PLANNING COMMISSION
STAFF REPORT

APPLICATION NO: Neighborhood Design Plan No. NDP-25-19. River Islands Amendments to the Community at South River Bend, East Village, Lakeside East, Lakeside West, Old River, West Village Age Restricted Neighborhoods, West Village Non-Age Restricted Neighborhoods, Lake Harbor West, & Woodlands East District Architectural Design Guidelines and Development Standards (DG/DS)

REQUEST: Planning Commission to Consider Adoption of a Resolution to Approve Amendments to the Community at South River Bend, East Village, Lakeside East, Lakeside West, Old River, West Village Age Restricted Neighborhoods, West Village Non-Age Restricted Neighborhoods, Lake Harbor West, & Woodlands East Districts Architectural Design Guidelines and Development Standards (DG/DS) for the River Islands at Lathrop.

Figure 3-5: Builder Responsibility at Rear Yards*

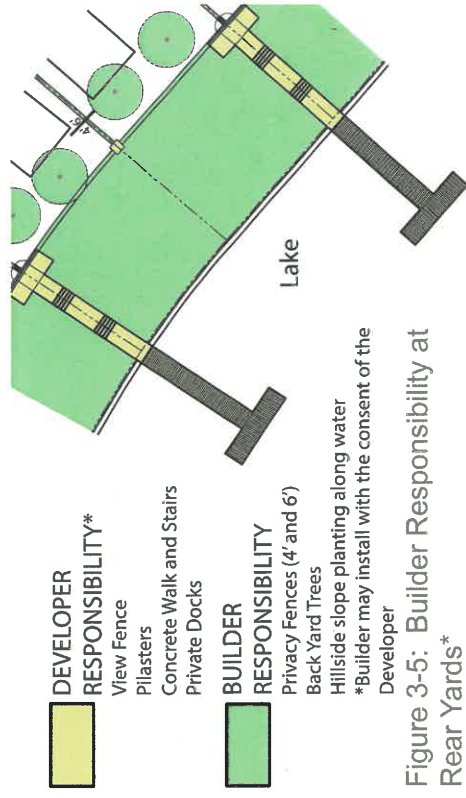
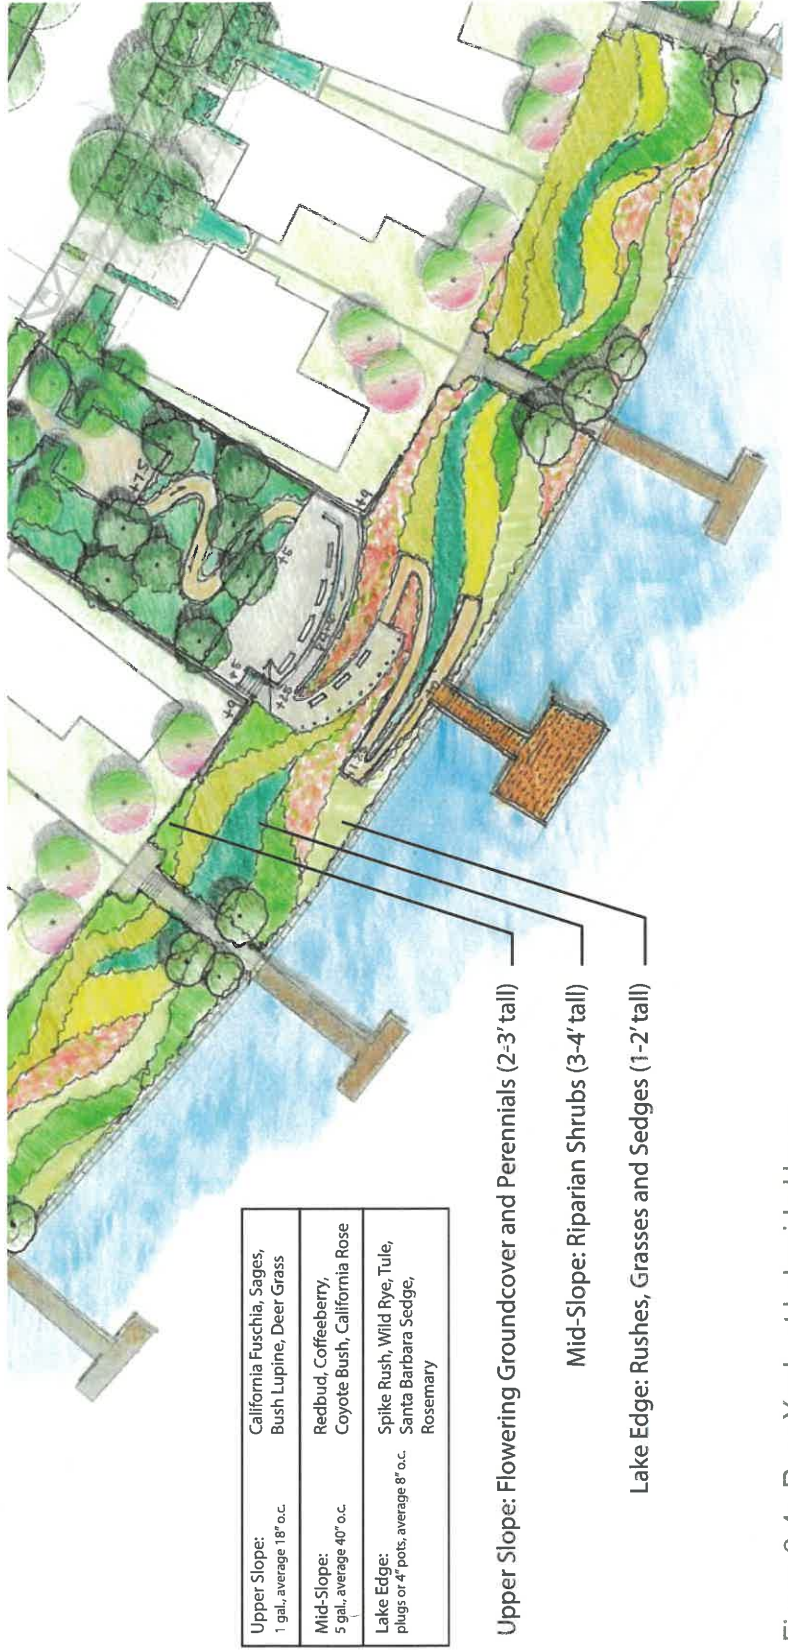
needs to be 69

Figure 3-7: Typical Alley Condition

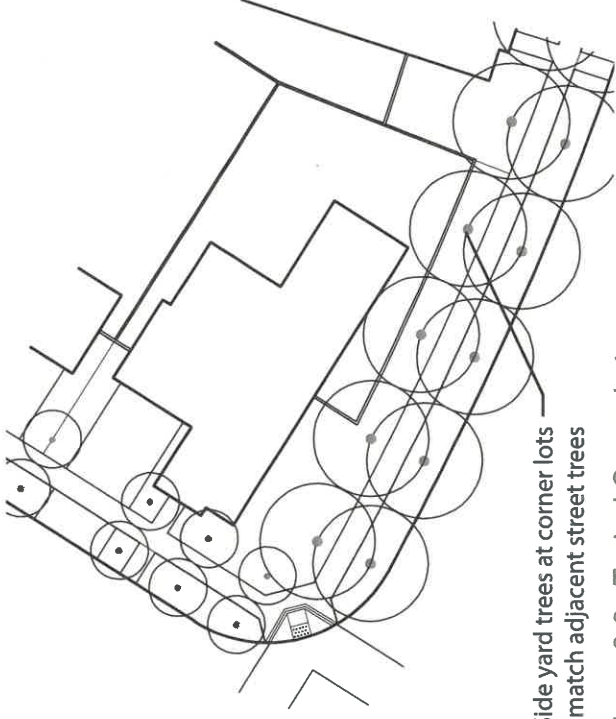
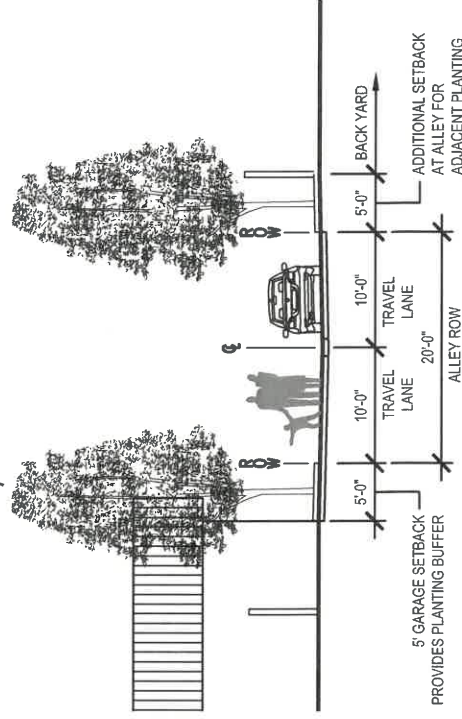
needs to be 2.

Figure 3-4: Builder Responsibility at Rear Yards

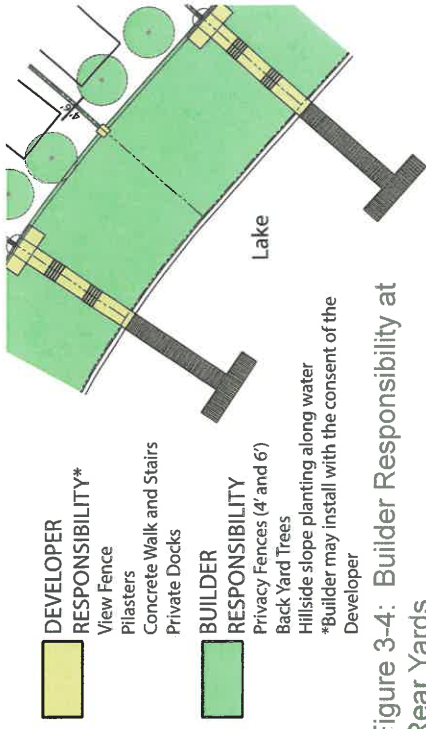
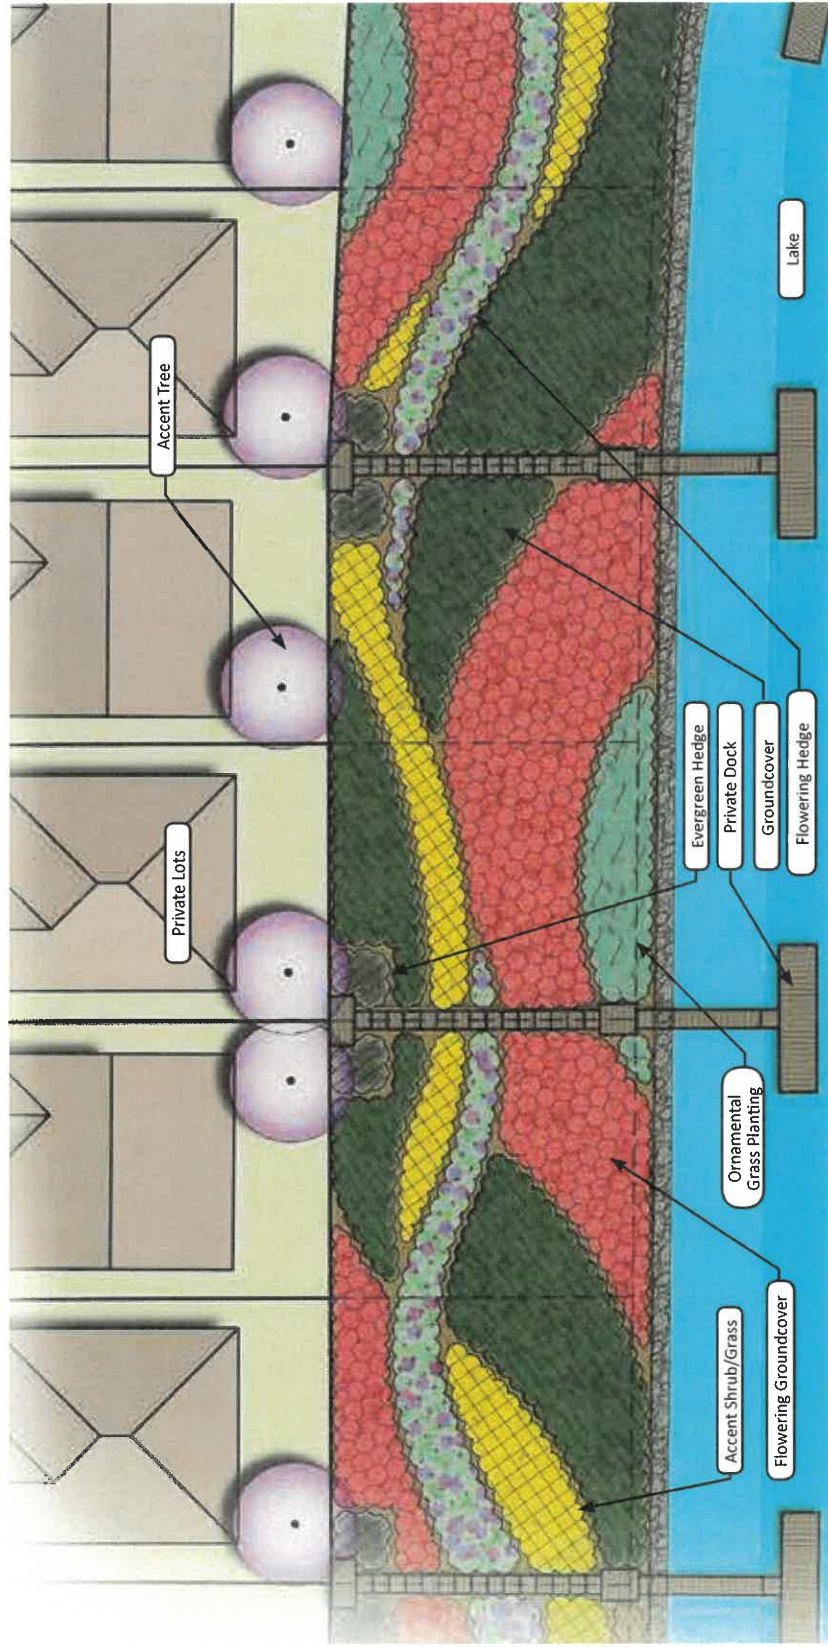
1. Areas between the homeowners' fence and the lake's edge (lake slope) shall be the responsibility of the homeowner to maintain.
2. Any proposed modifications to lake slope landscaping and irrigation shall be reviewed by the relevant public agency owning the slope and by the River Islands CC&R Team prior to any changes.

Figure 3-4: Builder Responsibility at Rear Yards

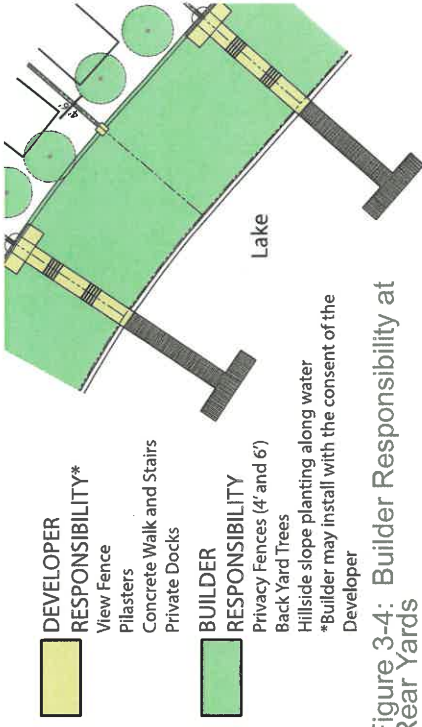
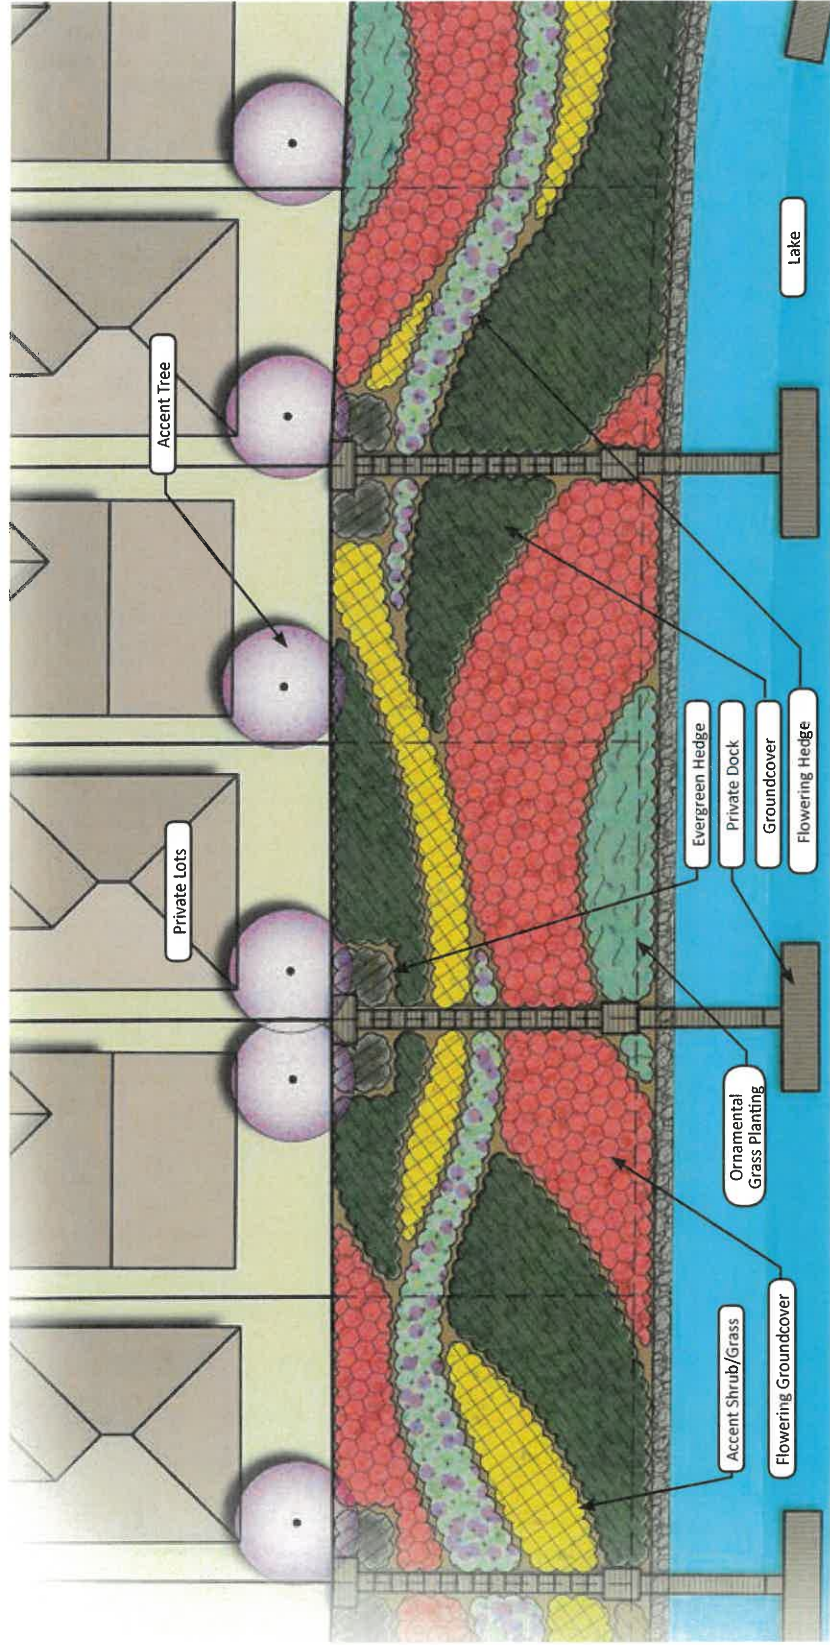
1. Areas between the homeowners' fence and the lake's edge (lake slope) shall be the responsibility of the homeowner to maintain.
2. Any proposed modifications to lake slope landscaping and irrigation shall be reviewed by the relevant public agency owning the slope and by the River Islands CC&R Team prior to any changes.

Figure 3-4: Builder Responsibility at Rear Yards

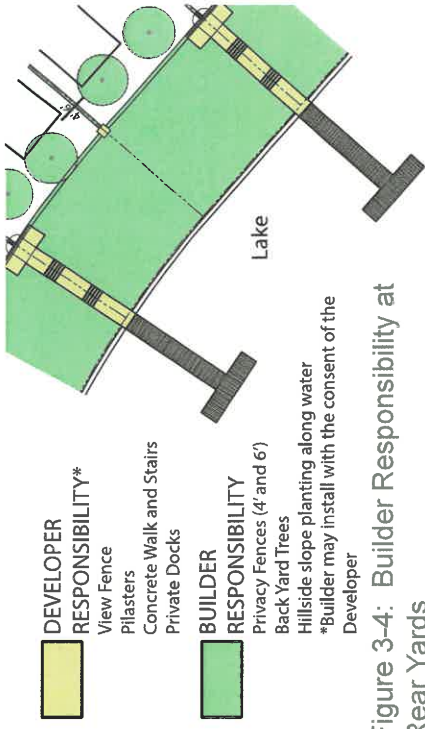
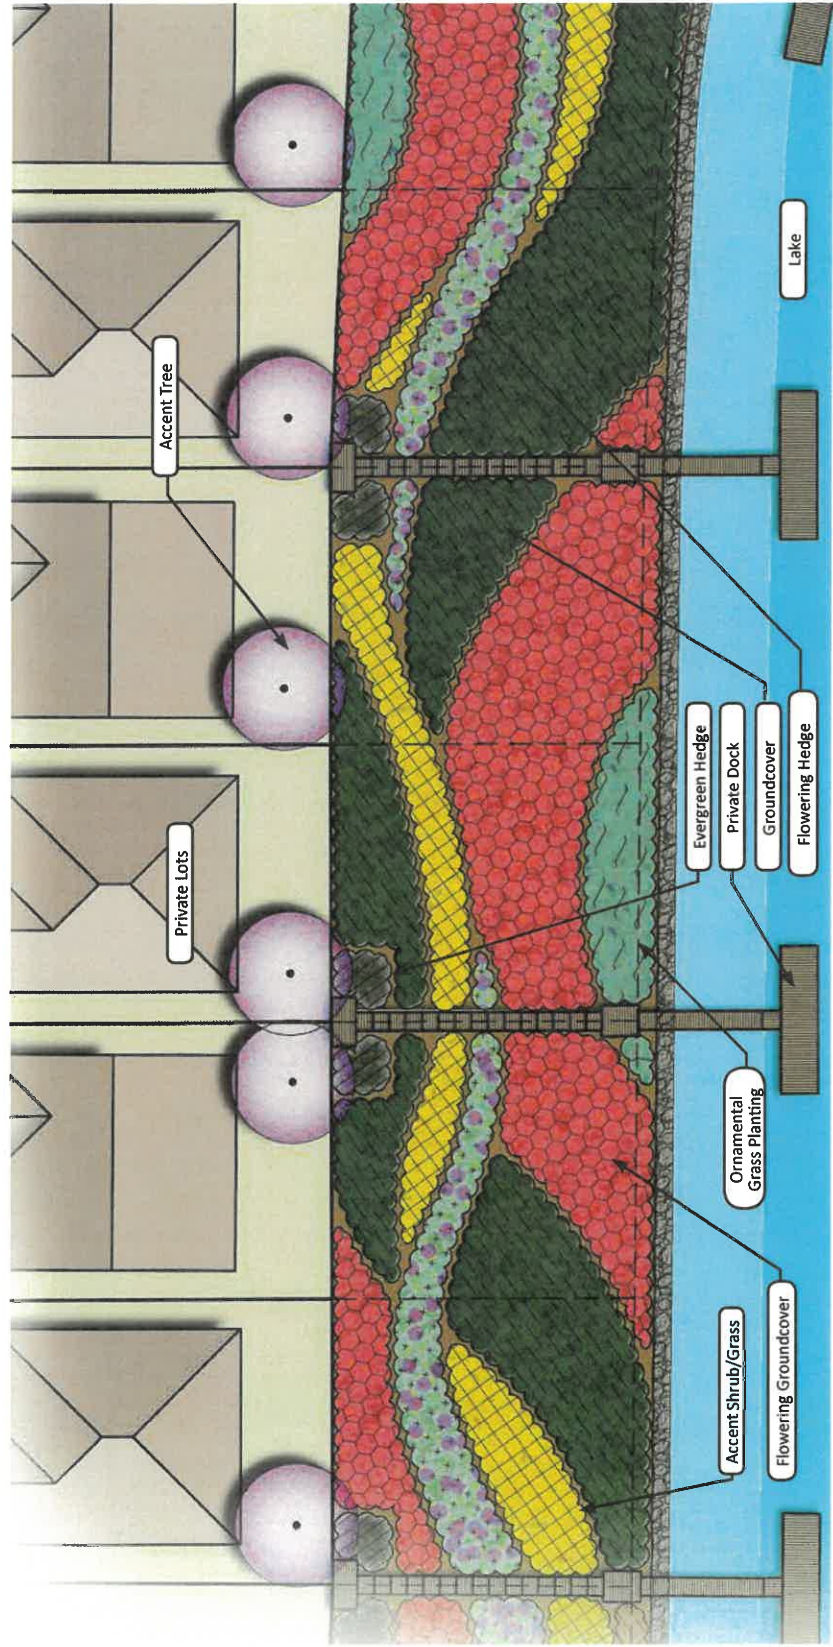
1. Areas between the homeowners' fence and the lake's edge (lake slope) shall be the responsibility of the homeowner to maintain.
2. Any proposed modifications to lake slope landscaping and irrigation shall be reviewed the relevant public agency owning the slope and by the River Islands CC&R Team prior to any changes.

Figure 3-4: Builder Responsibility at Rear Yards

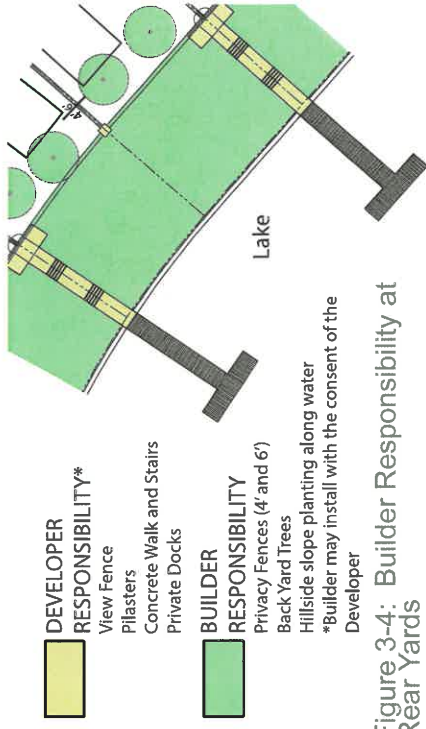
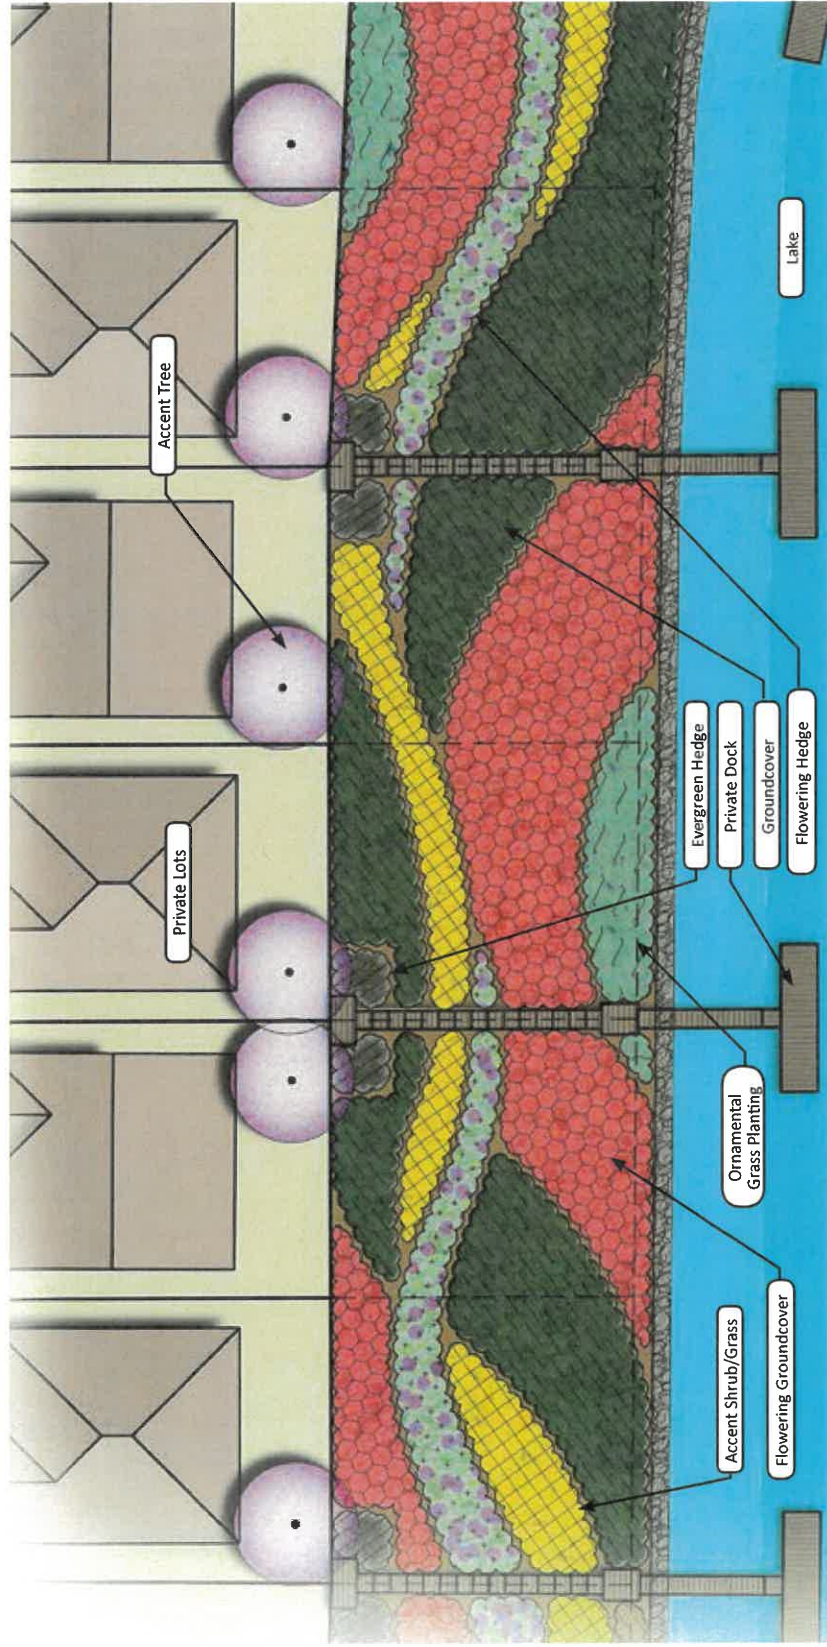
1. Areas between the homeowners' fence and the lake's edge (lake slope) shall be the responsibility of the homeowner to maintain.
2. Any proposed modifications to lake slope landscaping and irrigation shall be reviewed by the relevant public agency owning the slope and by the River Islands CC&R Team prior to any changes.

Figure 3-4: Builder Responsibility at Rear Yards

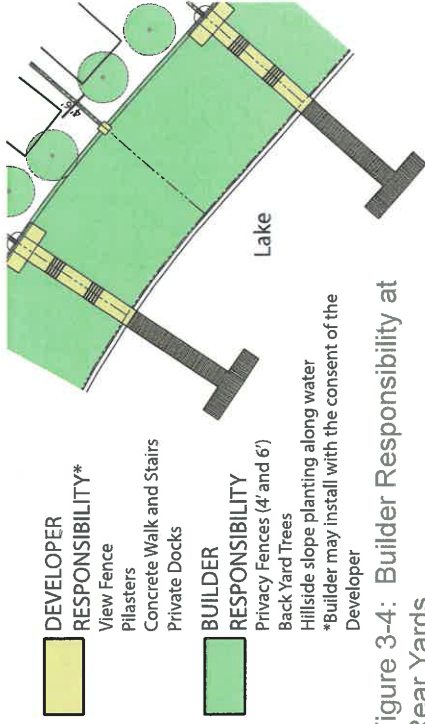
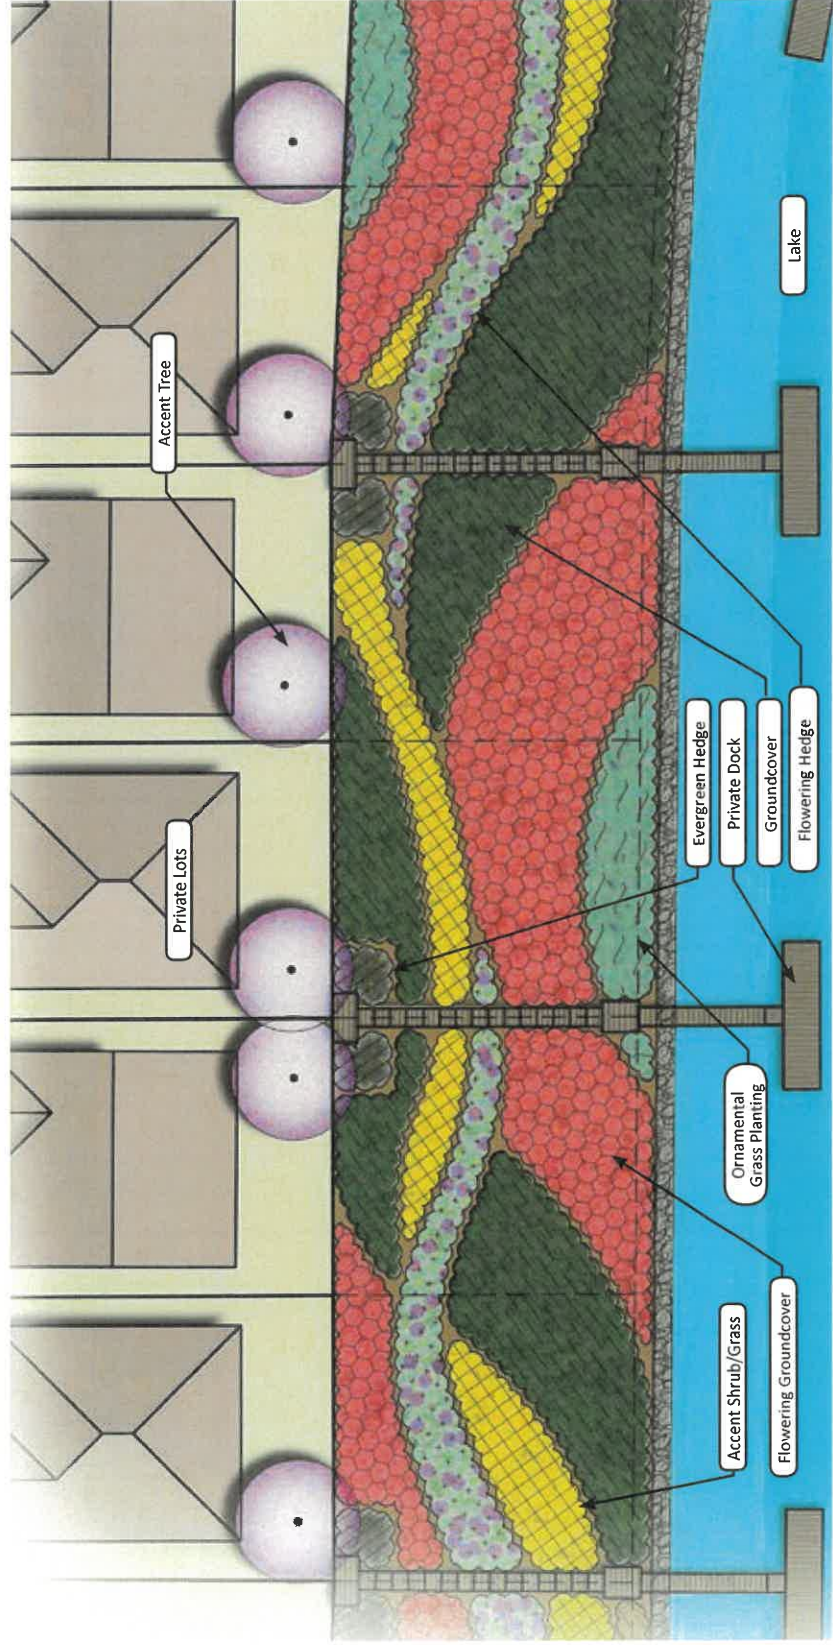
1. Areas between the homeowners' fence and the lake's edge (lake slope) shall be the responsibility of the homeowner to maintain.
2. Any proposed modifications to lake slope landscaping and irrigation shall be reviewed by the relevant public agency owning the slope and by the River Islands CC&R Team prior to any changes.
